17 April 2020

Edition 8

AUSTRALIAN NOTICES TO MARINERS

Notices 300 - 331

© Commonwealth of Australia 2020
Block for chart Aus 335 (55.6 x 84.2mm)

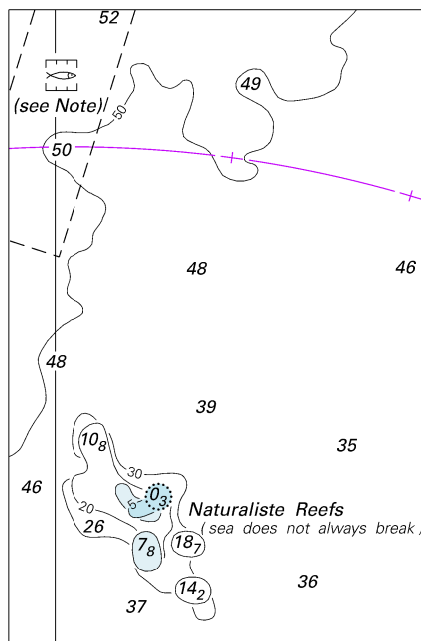
Aus 335 [18/2020]

Insert	accompanying block	33° 11'.2 S	115° 04'.1 E
--------	--------------------	-------------	--------------

© Commonwealth of Australia 2020
Block for chart Aus 755 (65.5 x 60.8mm)

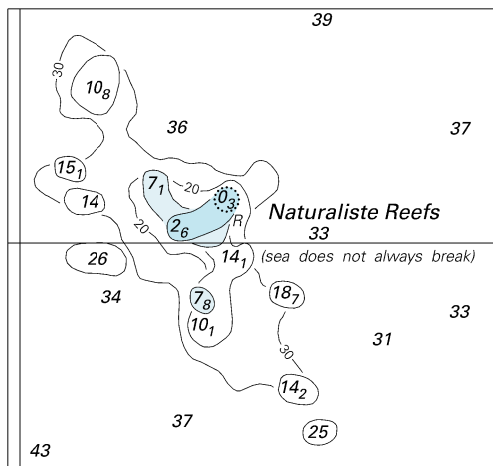
Aus 755 [237/2020]

Insert	accompanying block	33° 15'.0 S	115° 03'.0 E
--------	--------------------	-------------	--------------
